**City of Gainesville
Department of Community Development
Current Planning Division
Summary of Technical Review Committee Comments**

Petition: 82SUB-01DB	Development Review Board
Meeting Date: 9/13/01	Reviewed by: Bedez E. Massey
Project Name/Description: Design plat review for 88 lots on 44.9 acres MOL. Zoned R1-a (Alachua County zoning). Located in the vicinity of SR 331 (Williston Road) and Southwest 21 st Street, north side.

CLIENT: GREENTRUST GAINESVILLE, FLORIDA
PROJECT: MADERA CLUSTER SUBDIVISION
SHEET NO.: 2 OF 3
DESIGN PLAT

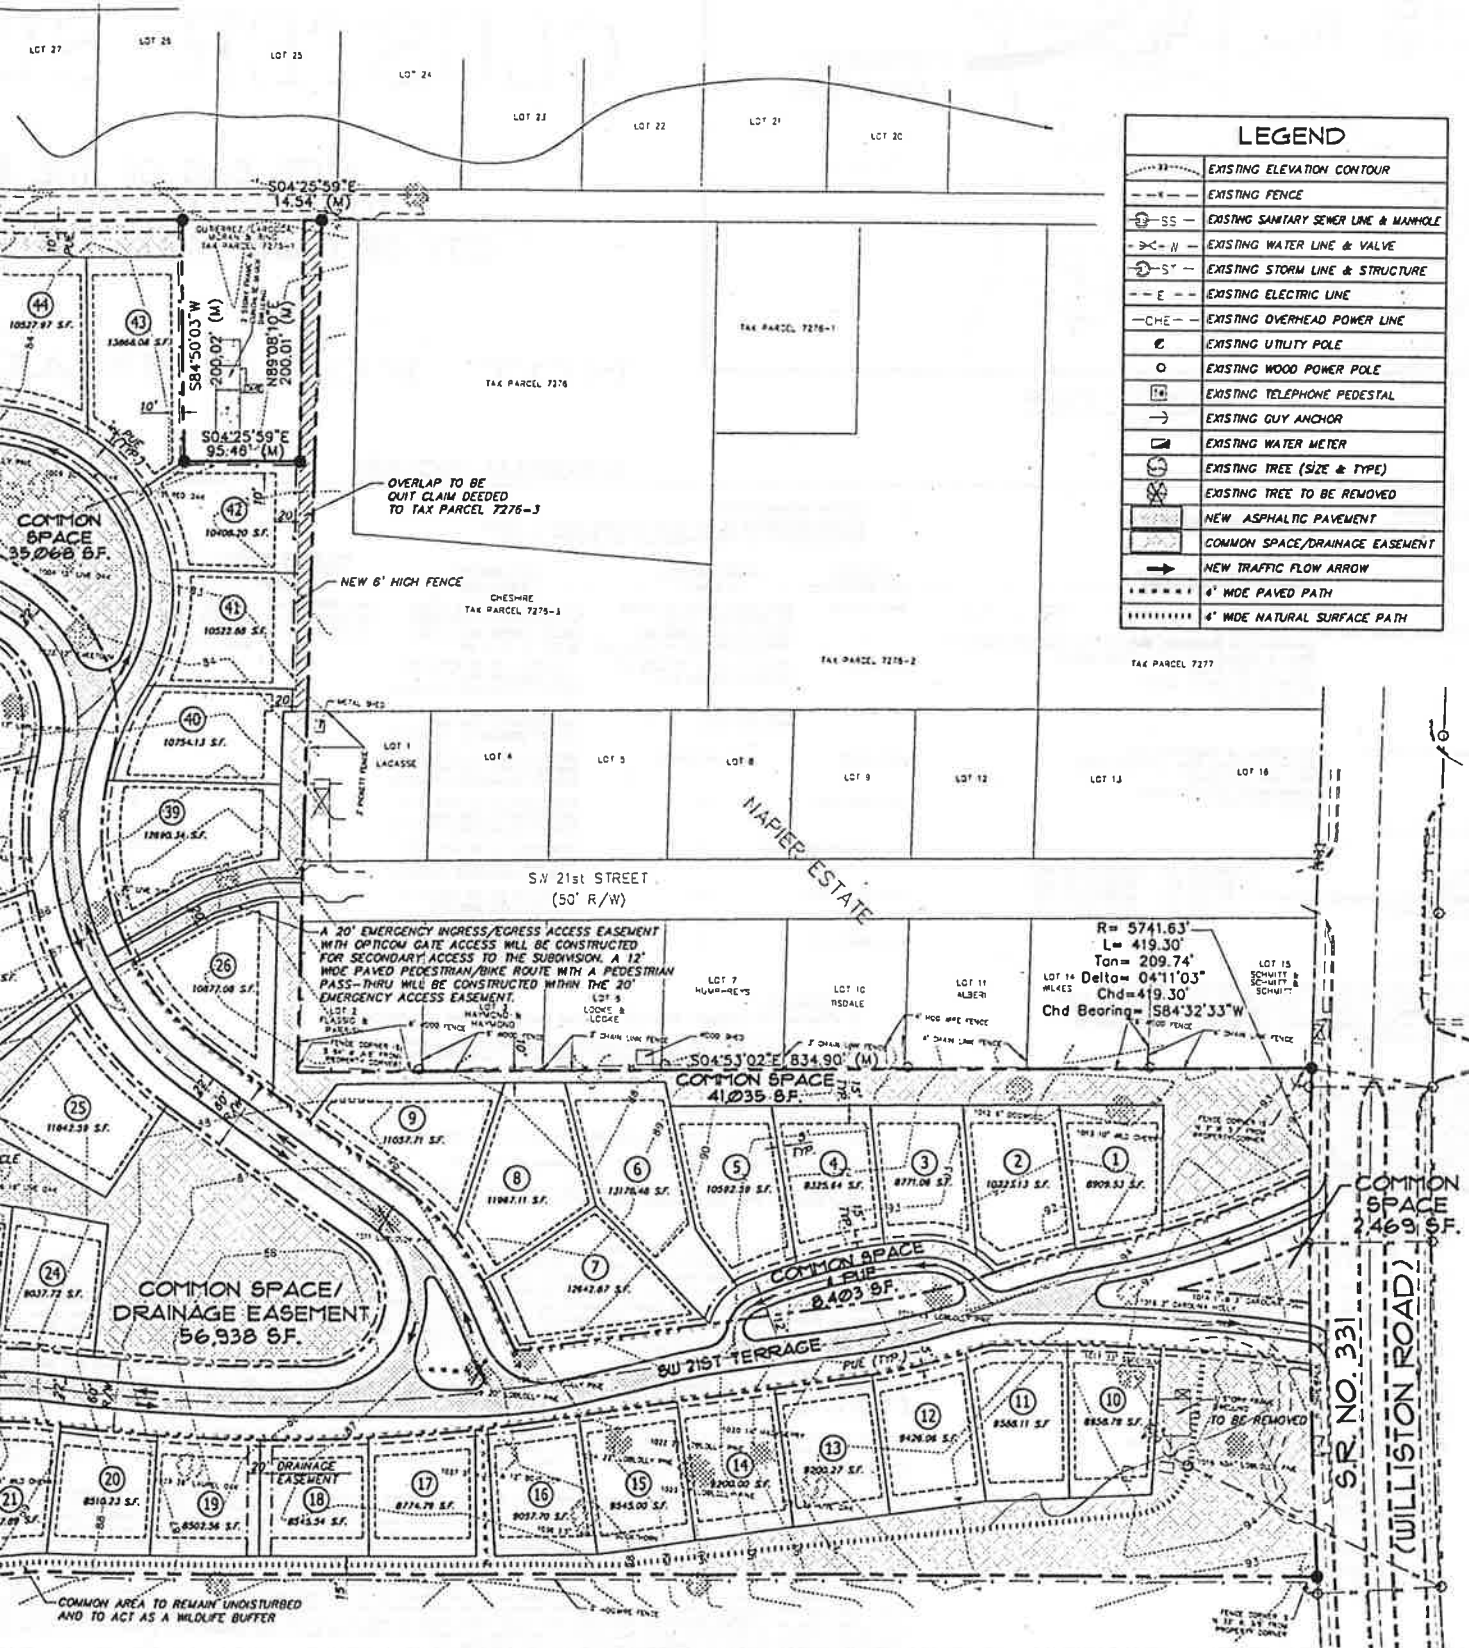
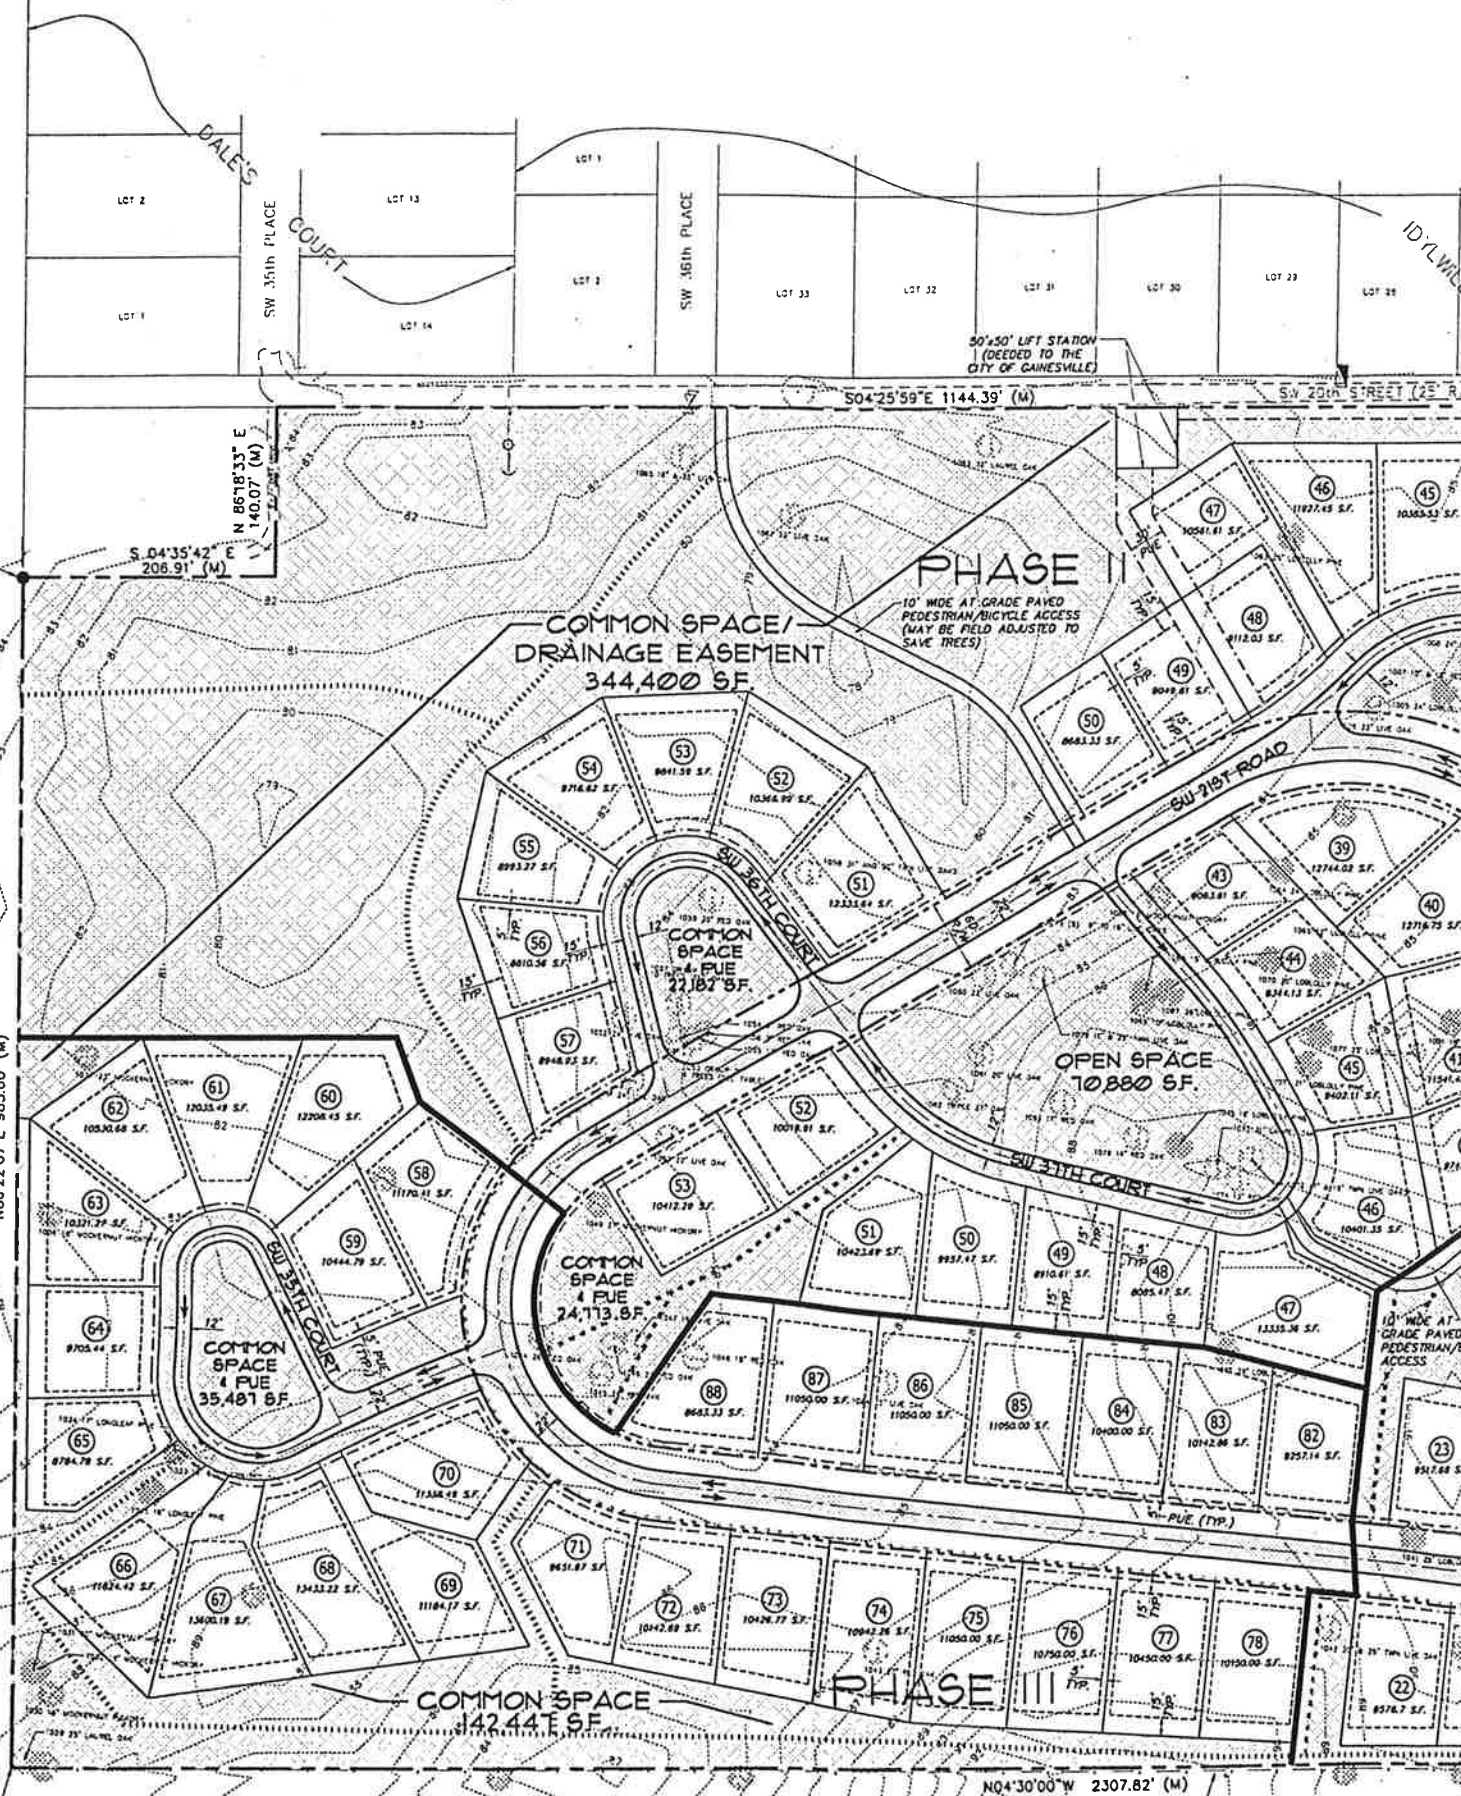
4. The legal description and all other data provided on the design plat shall reflect the amount of land removed by the quit claim deed. The southern project boundary shall also be modified.

5. The boundaries of Phase I and II shall be more clearly delineated on the design plat. Staff cannot determine where the two phases are separated.
6. The lift station shall be buffered from the residential structures located to the east. The type of buffer shall be indicated on the design plat.

7. The existing structure shown in the southwest corner of the development site shall be removed prior to the submittal of the final plat application. Please consult with the City Historic Preservation Planner prior to filing for a demolition permit.

10. The design plat shall specify the type material to be used for the fence proposed along the development site.
11. Please label the 5th column in Item G. on Sheet 1 as follows: "Cluster Subdivision Requirements," so that it is clear to city staff that these are the requirements to be enforced.

12. Please be reminded that this petition covers design plat approval for all phases of the proposed cluster subdivision. Please modify Note 10 on Sheet 1 accordingly.

13. Please be reminded that the Alachua County cluster subdivision requirements state that the notation "Cluster Development" shall be included within the title of the subdivision.

- a. A note should be added to the plan regarding the removal of the existing structure
- b. The plan should include the locations of the proposed pedestrian/bicycle access points and off-street trails with notes regarding their placement to minimize impacts to protected trees.
- c. Remove the building outline from the common area abutting Williston Road.
- d. Please advise the applicant to evaluate the proposed building envelopes. Construction on lots such as 18 and 19 may be difficult without impacting the buffer area.
